WALNUT CREEK ADDITION
(DRAINAGE)

CONFIRMATION MEMO

PROJECT: WALNUT CREEK ADDN
JOB NO.:
DATE: 2-15-84
COPIES TO:
TO: CHRIS BREITENSTEIN
FROM: E. WOOTEN
REFERENCE: FINAL DRAINAGE PLAN

WALNUT CREEK ADDITION

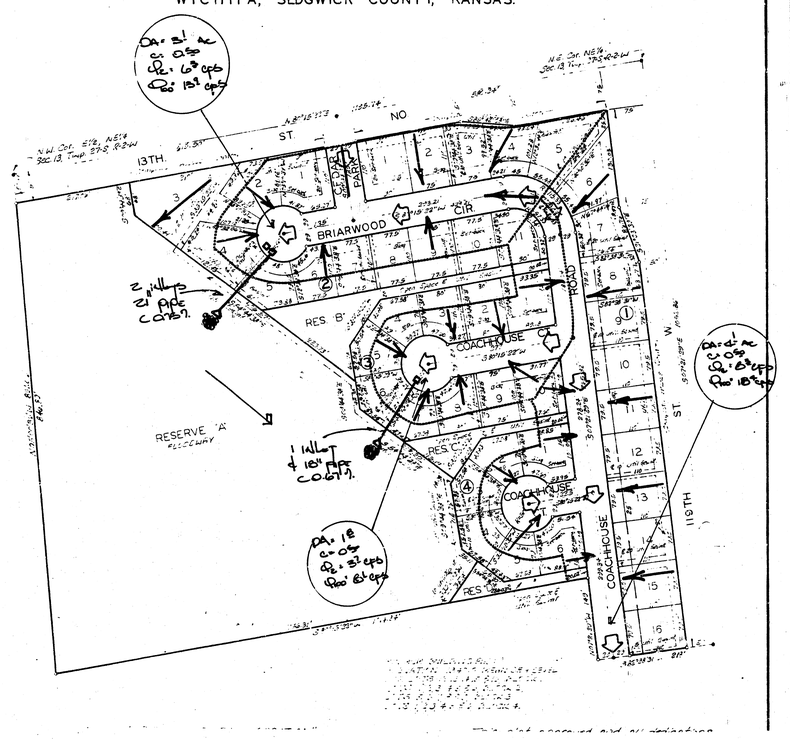
A) Drainage plan acceptable. Need guarantee of SWS.

Lots shall extend into floodway. Rear lot lines should conform to floodway boundaries.

Require offsite drainage easement to drain Coachhouse Court south to creek

B) SS layout acceptable (extend Beaumont (Continued thru any other) down from north)
Bldg setback = setting [illegible] 20' [illegible]
* Request addtl. R/W on SS 13th
near bridge
* Lot 3 partially (14.8' at curb)
* Change platting bdy to read "appropriate governmental agency."
